| APICAL INDUSTRIES, INC. | ENGINEERING CHANGE NOTIC. NO. 03294 | | | | SHEET 1 OF 1 | |
| | DWG NO. 647.9100 | REV: N/C | PREPARED BY A. QUAN | DATE: 12/07/11 | EFFECT ON DWG <input type="checkbox"/> INC. <input checked="" type="checkbox"/> UNINC. | |
| | DWG TITLE: THRUSERTS | | | | | |
| TRANSACTION CODES (TC): A-ADD C-CREATE R-REVISE D-DELETE | | REASON: REVISED MATERIAL DUE TO AVAILABILITY ISSUES | | | | |

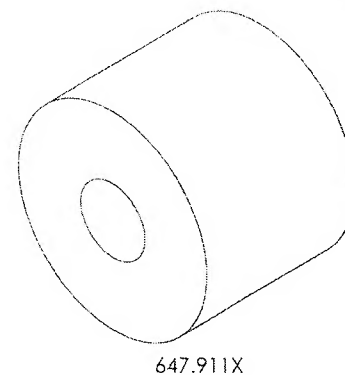
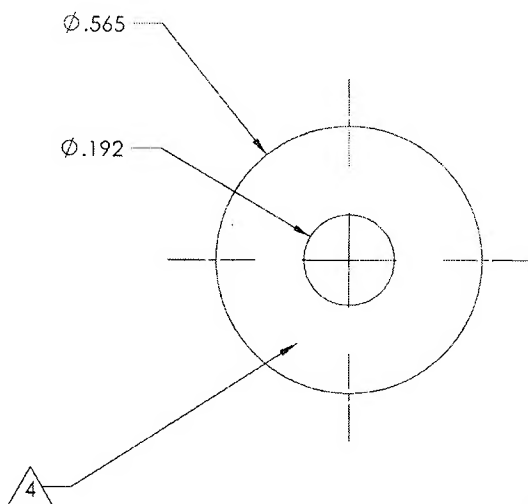
SHEET 1, NOTES IS:

1. MATERIAL: 303 SS IAW AMS 5640.
2. FINISH: NONE
